City of San Luis

Re: Subdivision Case No. 2021 0751F-Los Mezquites Unit 1

City staff has reviewed the Final Plat 2nd submittal and staff has the following comments:

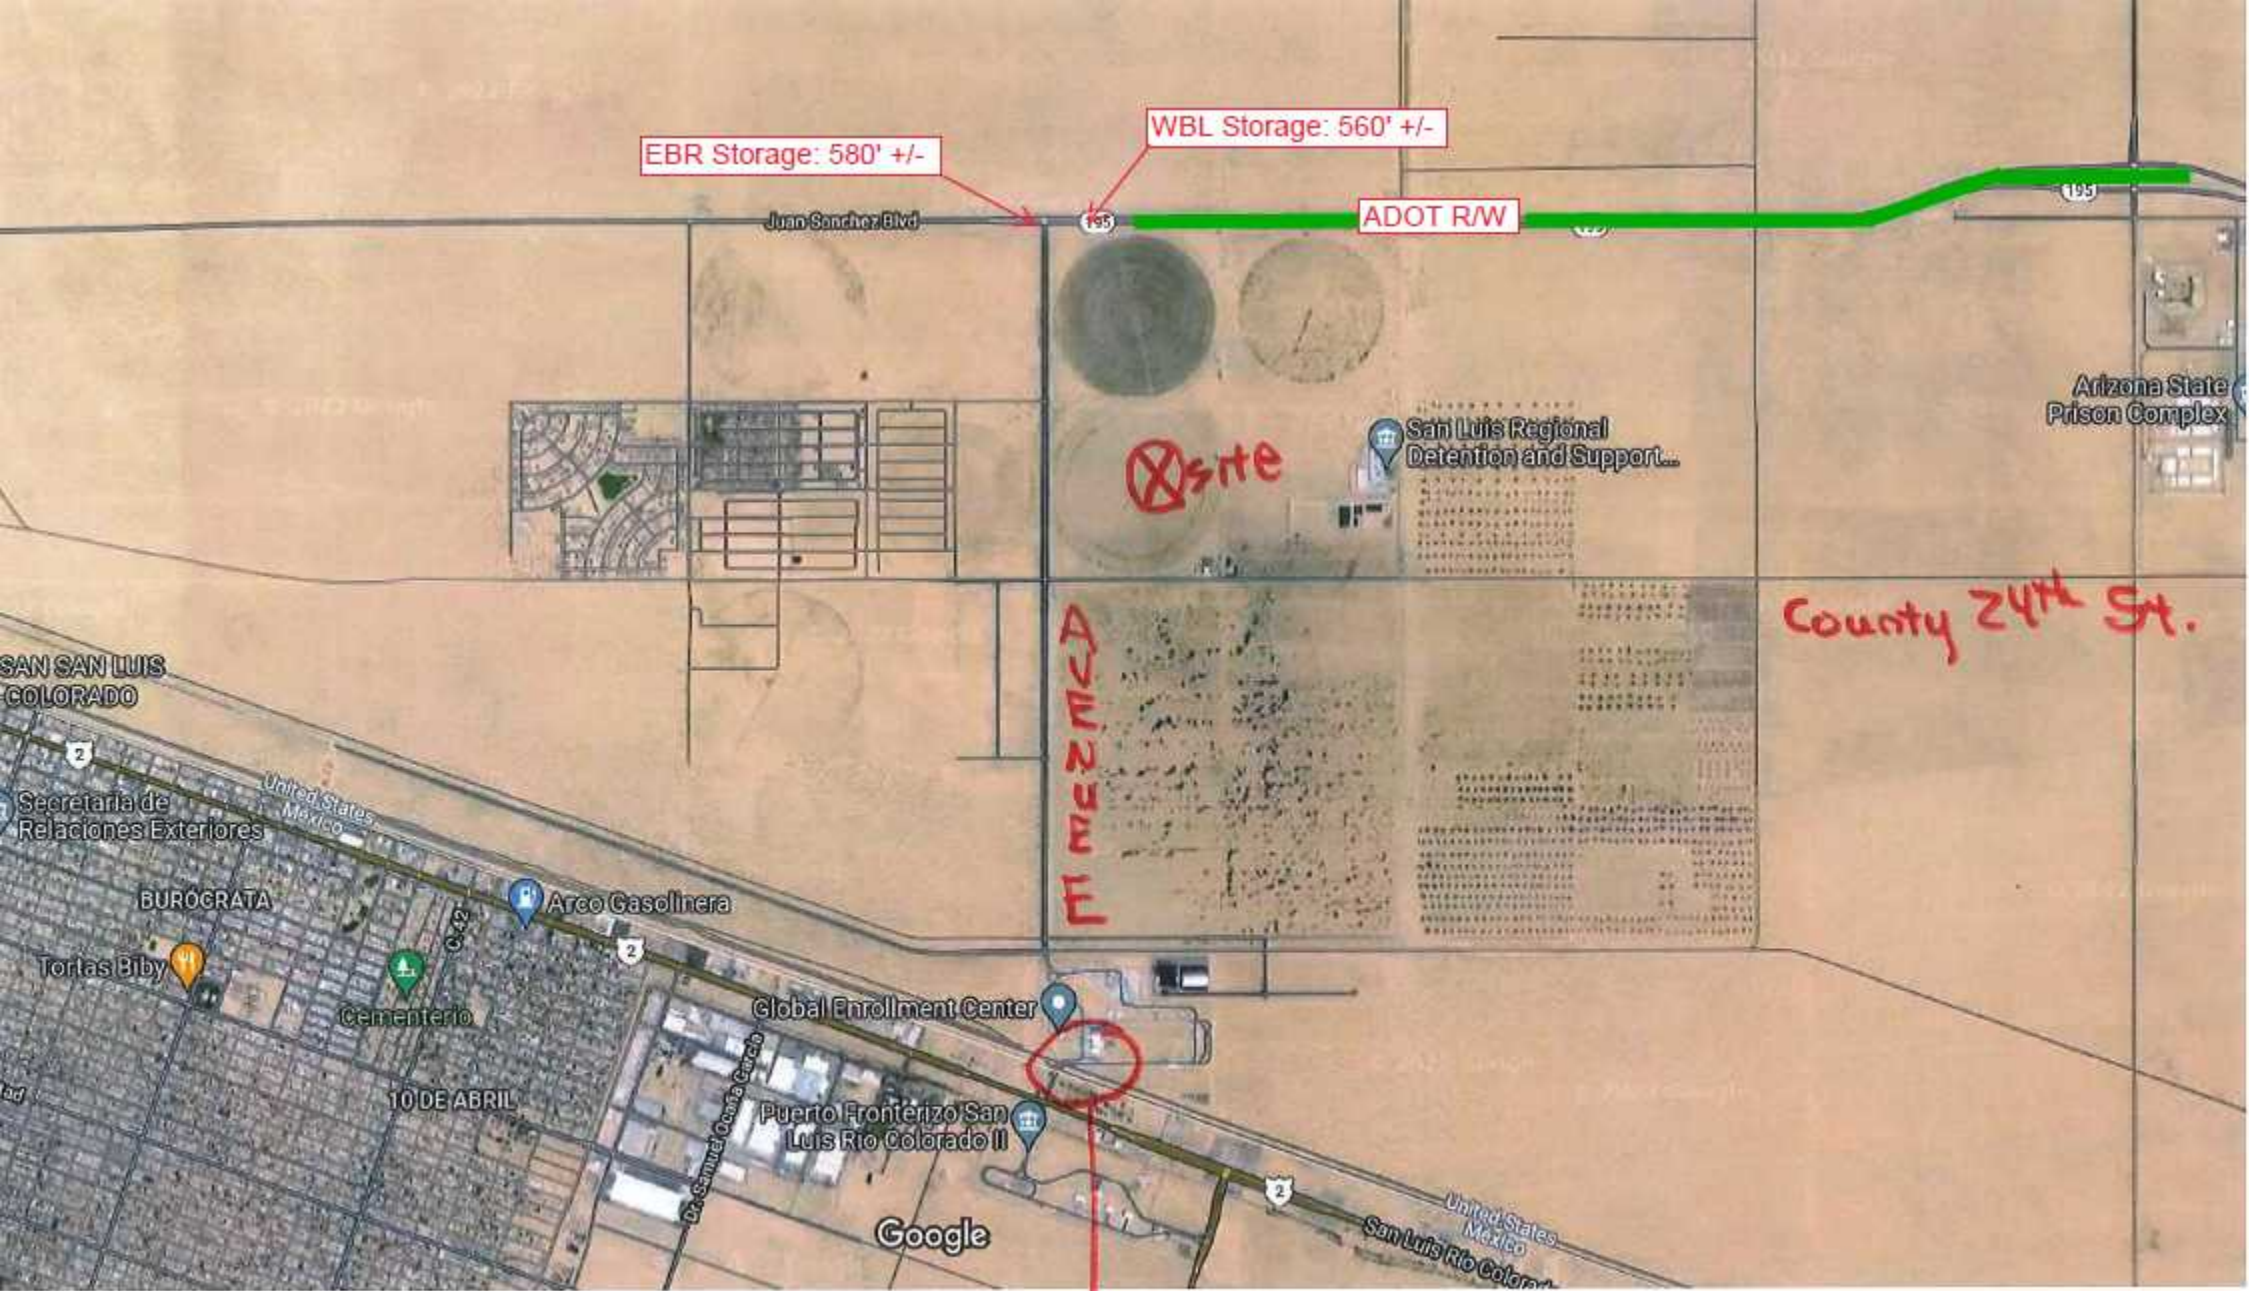
1. The intersection of Ave E/ Cesar Chavez Blvd is recommended to have dual left turn lanes in the WB direction. However, the Synchro calculation still shows LOS F in the year 2031.
2. Intersection Ave E/ Cesar Chavez Blvd: The existing storage for the WBL is about 560' and EBR is about 580' as shown in the sketch attached. Please verify the storage length that is used in the Synchro model. It seems 250' is used for both turn lanes.
3. The turn lane design should follow ADOT TGP 430 to determine the storage/ gap and taper for the intersection of Ave E/ Cesar Chavez. Please verify table 20.
4. Please provide the recommendations that have the LOS D or better for the intersection of Ave E/ Cesar Chavez in the year 2031 and 2036.

EBR Storage: 580' +/-

WBL Storage: 560' +/-
